SUBMISSIONS REPORT

Alexandria Health Centre

SSD-38600121

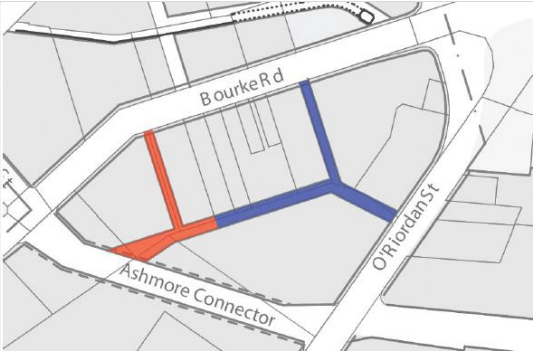
2. Urban Design	<p>The western and southern walls of the proposed building are to define the proposed laneway network. This does not occur on the western boundary because the cantilever of the upper levels over the driveway weakens the definition of the lane.</p> <p>The western and southern walls of the proposed building are to define the proposed laneway network. This does not occur on the western boundary because the cantilever of the upper levels over the driveway weakens the definition of the lane.</p>	<p>Noted and accepted – design detail subject to the design competition and to be documented as part of the detailed SSDA.</p> <p>It is highlighted that the Concept SSDA seeks approval for a concept envelope that goes to the boundaries of the site (after dedication), including the north, west and south boundaries.</p> <p>The Concept SSDA does not seek approval for the reference scheme. The detailed design will be subject to a design competition and addressed as part of the Detailed SSDA submission.</p> <p>In relation to the Sydney DCP 2012 , it is noted that its provisions do not strictly apply to an SSDA. Nevertheless, in response to</p>

Item	Issue	Response
		Council's submission, the architectural design competition brief (currently being developed) has been prepared to note that 'competitors should explore opportunities for the western and southern walls of the proposed building to define the laneway network with minimum/nil setbacks, cantilevers and colonnades as envisaged in the Sydney DCP 2012.'
	The colonnade created by the large upper levels over the northern and part western boundaries is not appropriate. The building is a stand alone building and not part of a continuous colonnade. The building should come straight to the ground.	As above
	The southern boundary wall is to define the proposed laneway network. The 500mm setback for greenery is not supported and the building should be located on the boundary.	As above

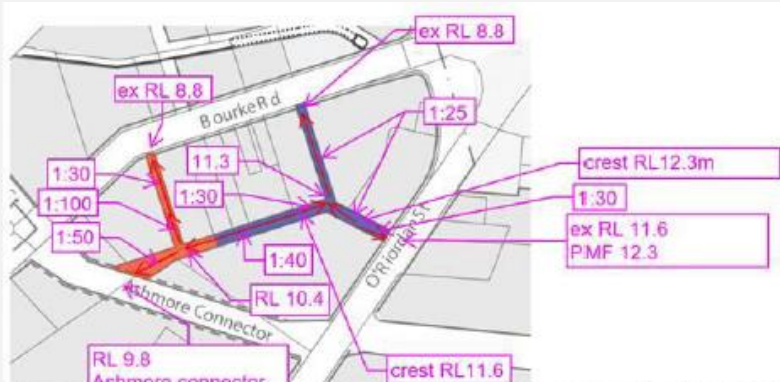
3. Western laneway	<p>The draft SDCP 2012 Southern Enterprise Area requires future laneway dedications on the western and southern boundaries of the site. The draft DCP controls intend for these laneways to be shared zones with pedestrian priority and oneway for vehicles (north towards Bourke Road).</p> <p>The proposal includes two stages for the future development of the site. It is noted that the options for stage 2 do not meet the intent of the DCP for the treatment and use of these laneways as 6 metre wide, shared laneways with oneway vehicular traffic. The City will continue to engage in discussions with the applicant on this matter.</p>	<p>Noted - design detail to be documented as part of the detailed SSDA.</p> <p>A meeting with Council's City Design Team occurred on 7 September 2022 to discuss the laneway design. It was acknowledged by Council that in the short to medium term (Stage 1 - i.e. before the full length of laneway is developed), vehicle ingress/egress for the site would need to occur at its western boundary, as documented in the Concept SSDA.</p> <p>In terms of long term design for the laneway (Stage 2 - i.e. when the neighbouring sites are developed and land dedication occurs to construct the full length of the laneway), we understand Council would like the final laneway design to reflect the DCP intent of a shared laneway with one-way vehicular traffic.</p> <p>Ongoing discussions are occurring with City of Sydney on this matter, which will be documented as part of the Detailed SSDA.</p>
